ADDENDUM NO. 1
TO
CITY OF AUBURN, MAINE
2015 RECLAMATION PROJECT
February 19, 2015

Valview Drive - Drainage Easements

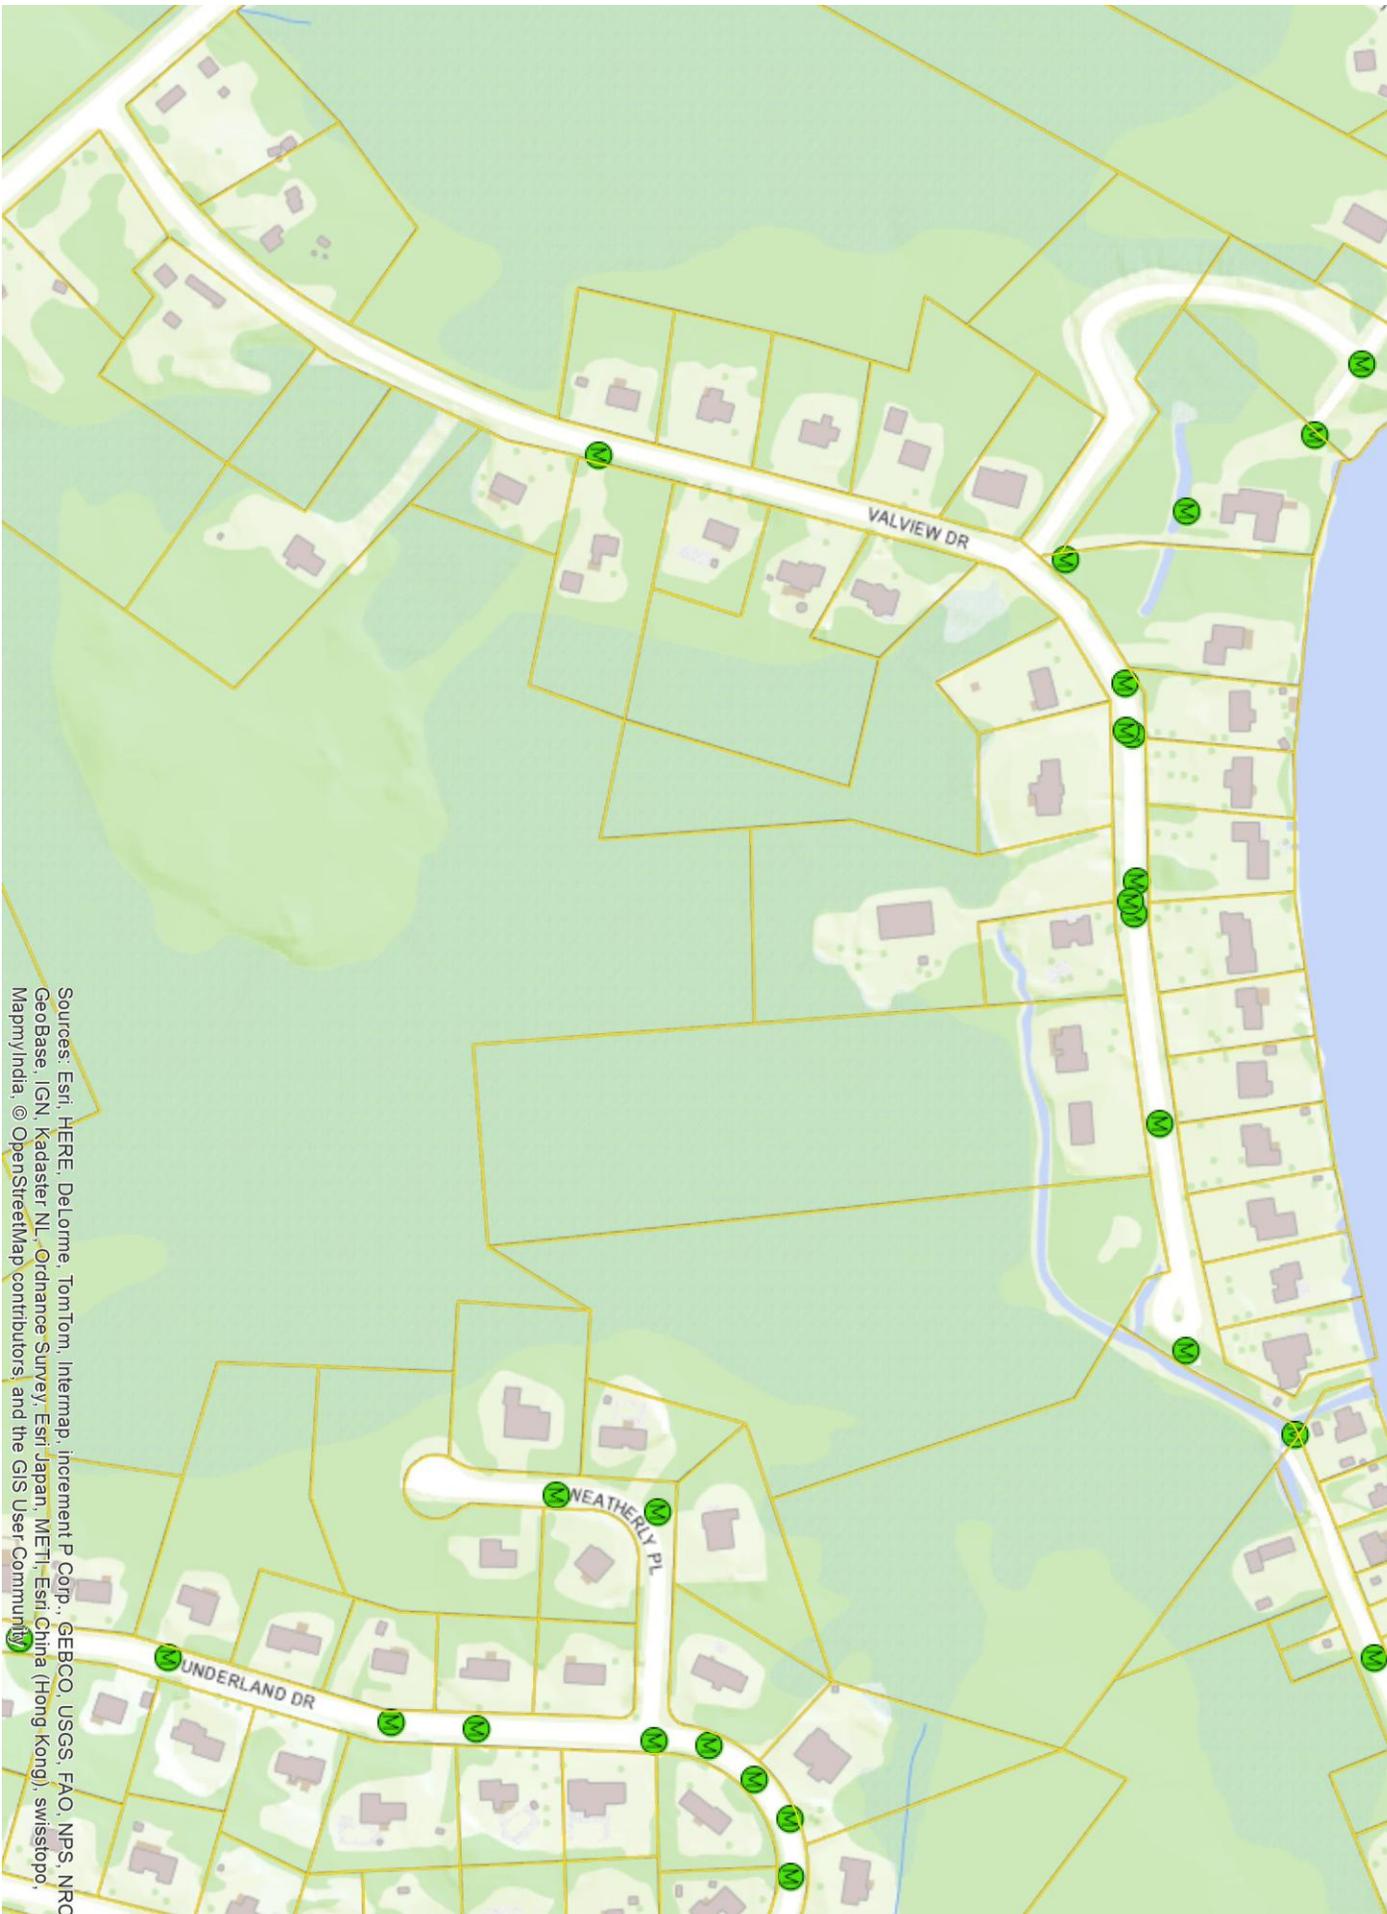
Question: For Item 211.50, does the City have locations and pictures that they can share? The current/recent weather conditions do not allow for an easy inspection.

Answer: A GIS map showing the two drainage easements on Valview Drive is provided in this addendum. Any permits required for this work will be acquired by the City.
